**PLANNED UNIT DEVELOPMENT
& SUBDIVISION STAFF REPORT****Date: March 19, 2009****DEVELOPMENT NAME**

Renaissance-Mobile Family Housing Subdivision

APPLICATION NUMBER 19 & 20 DATE March 19, 2009
APPLICANT Renaissance-Mobile Family Housing Subdivision
REQUEST Subdivision, Planned Unit Development

SITE PLAN

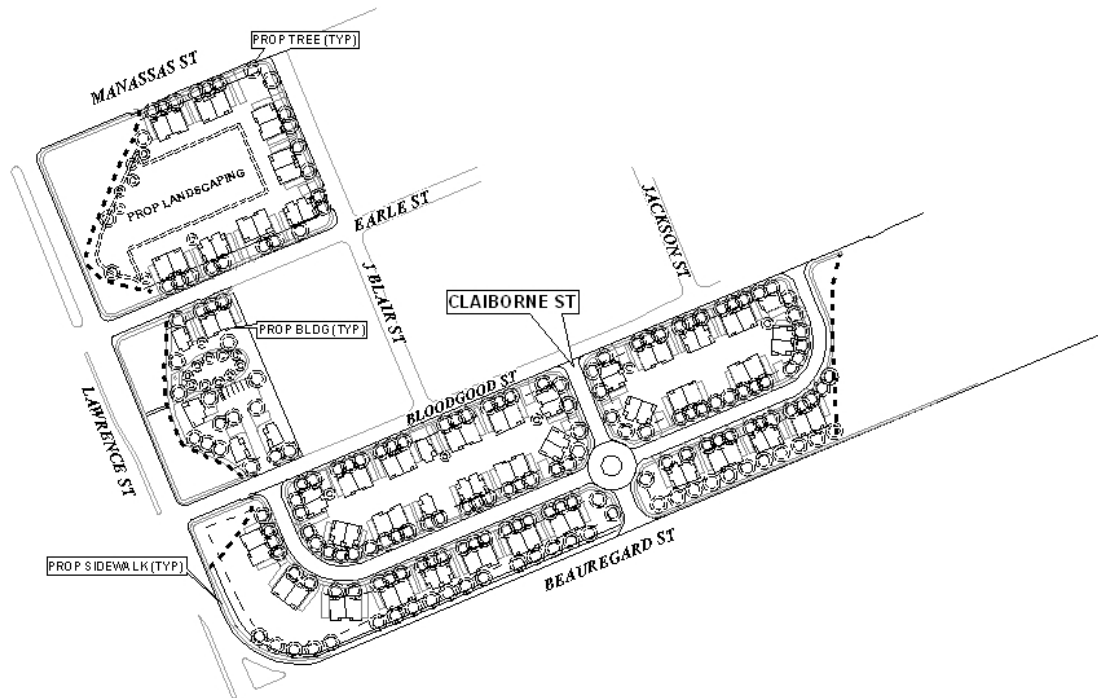
There are several discrepancies between the plat and the site plan. The plat indicates four common areas, while the site plan labels the areas as “outparcels.” The areas are not proposed for development as they are located in an “AE” floodzone, per FEMA designation, and the Mobile Housing Board is not allowed to utilize federal HOPE VI funds within the floodplain area for new construction. Staff believes, however, that those areas along Lawrence Street should be dedicated common areas. The largest area, bounded by Bloodgood, Conception and Beauregard Streets should either be designated a common area as well for the PUD, or should be converted into a legal lot (the lot could be sold for private development). The site plan or plat should be revised to depict dedicated common areas and/or new lots. If new lots are proposed, the application will be recommended to be heldover so that new notifications can be sent out to adjacent property owners, and so that new drawings can be submitted. The Mobile Housing Board may reapply at a future date to convert common area 2 to a legal lot, should they wish to sell it, as long as no required trees or landscape areas are lost due to the sale of common area 2.

The second discrepancy relates to the depiction of the boundaries of the proposed lots, specifically at the street corners. The plat reflects, generally, a radius at each corner, while the site plans are inconsistent. The site plans should be revised to mirror the plat, once the plat is revised to provide a radius at the Earle and Conception corners previously mentioned.

It should also be pointed out that there is no indication as to the presence of overhead power lines. Where overhead powerlines exist, tree selection within 15 feet (measured horizontally) is limited to live oaks for any required overstory tree, and crepe myrtles for any required understory tree. A note should be placed on the site plan stating this, and any overhead powerlines to remain should be indicated on the site plan.

No dumpster is depicted on the site plan. If a dumpster is proposed, it should be depicted on the site plan (meeting setback and screening requirements, and not changing on-site circulation), or a statement should be provided indicating that no dumpster will be included as part of the development. If the Mobile Housing Board will provide garbage service, a note should be placed on the site plan stating such.

- 3) Revision of the site plan to show all “outparcels” as common areas, matching those indicated on the Subdivision plat, including proposed common area 5 recommended by staff;

- 4) Revision of the site plan to show lot boundaries matching those depicted on the Subdivision plat, including the required radius of lot lines at street corners;

- 6) Placement of a note on the site plan stating that any tree planted within 15 feet of an overhead powerline shall be either live oak (overstory) or crepe myrtle (understory), and depiction of any overhead powerlines that will remain after redevelopment;

- 7) Revision of the site plan to include a statement regarding the provision of a dumpster (*dumpster, if provided, to meet setback and screening requirements, and not change site circulation*), or placement of a note on the site plan stating that dumpsters will not be provided as part of the development, and how garbage disposal for the residences will be accomplished;

- 8) Placement of a note on the site plan stating that lots and residences are denied direct access to Lawrence Street and Beauregard Streets, and are limited to access to the minor streets of Manassas, J. Blair, Earle, Bloodgood, Claiborne, Conception, and the proposed new street;

SUBDIVISION PLAT

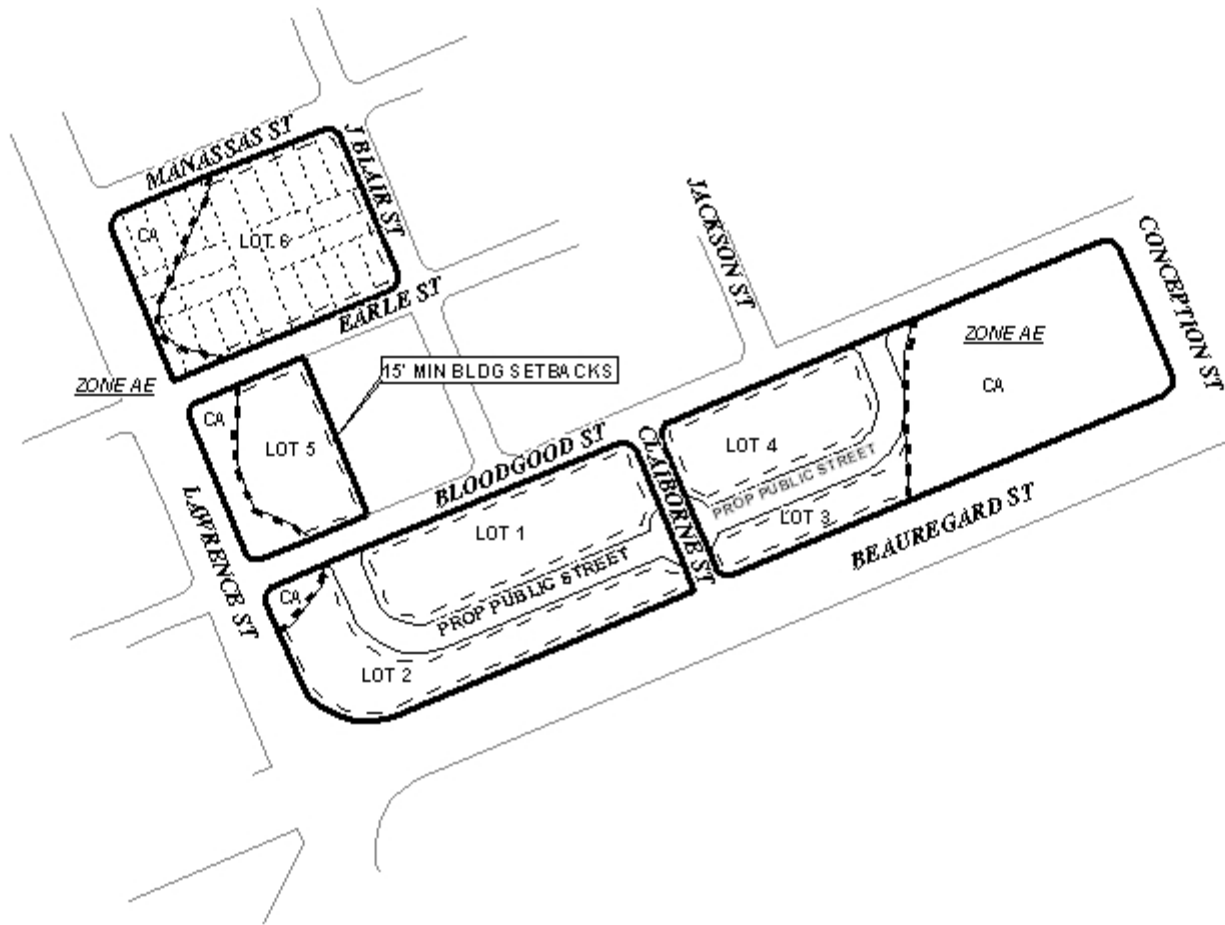
The site has frontage on two major streets and five to six minor streets. The rights-of-way for all existing streets meet the width requirements of the Subdivision Regulations and the Major Street Plan component of the Comprehensive Plan. There is, however, an issue regarding the radii at corners where Claiborne intersects Beauregard Street, and where Earle intersects Lawrence Street: the corners should be a radius, to be approved by Engineering and Traffic Engineering, essentially matching the other existing radii.

A fifth common area may be required for the small portion of land outside of the floodplain, located at the corner of the proposed street and Bloodgood Street, adjacent to common area 2.

The plat contains a note stating that all common areas will be maintained by the Mobile Housing Board. This note should be retained on the final plat.

Finally, there is an error in the legal description for common area 4: the description refers to Bloodgood, when it should refer to Earle Street.

- 3) Correction of the legal description for common area 4;
- 4) Revision of the plat to create a common area 5, adjacent to the proposed new street, Bloodgood Street and common area 2;

- 5) Revision of the plat to provide the appropriate radius for lot corners located at Earle and Lawrence Streets and Claiborne and Beauregard Streets, to be approved by Engineering and Traffic Engineering;

- 6) Placement of a note on the final plat stating that lots are denied direct access to Lawrence Street and Beauregard Streets, and are limited to access to the minor streets of Manassas, J. Blair, Earle, Bloodgood, Claiborne, Conception, and the proposed new street;
- 7) Compliance with all local, state and federal requirements for floodplain and endangered/threatened species issues;
- 8) Completion of the Subdivision process prior to the issuance of final certificates of occupancy; and
- 9) Full compliance with all other municipal codes and ordinances.
